CITY OF NOVI BOSCO PARK JSP18-42

Consideration at the request of City of Novi for Planning Commission's approval of Preliminary Site Plan and Stormwater Management Plan. The subject property is currently zoned RA, Residential Acreage and is located in Section 20, west of Beck Road and south of Eleven Mile Avenue. The applicant is proposing to build a total 13 outdoor soccer fields of varied sizes with 298 parking spaces on site. The Planning Commission is asked to consider the location, character, and extent of the improvements proposed as a City park, per state law.

PLANNING REVIEW

Review Date: September 17, 2018
Review Type: Preliminary/Final Site Plan
Project Name: JSP 18-42 CITY OF NOVI BOSCO PARK
Plan Date: August 20, 2018
Prepared by: Sri Komaragiri, Planner
Contact: E-mail: skomaragiri@cityofnovi.org; Phone: (248) 735-5607

Corner Clearance (Zoning Sec 5.9)

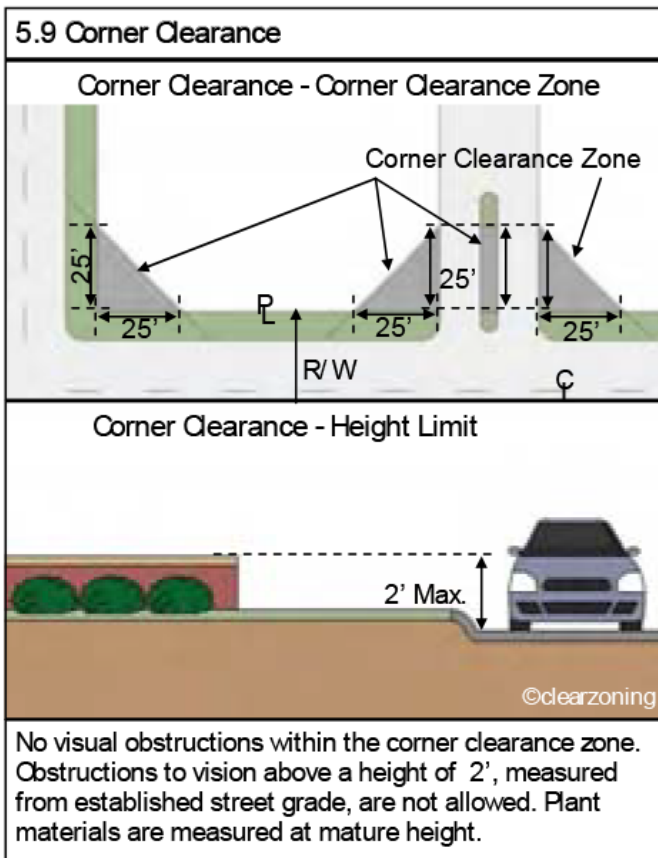
1. Provided, but drawn incorrectly. It should reference the property line, not edge of pavement

2. Please correct the clear vision zones per the diagram below.
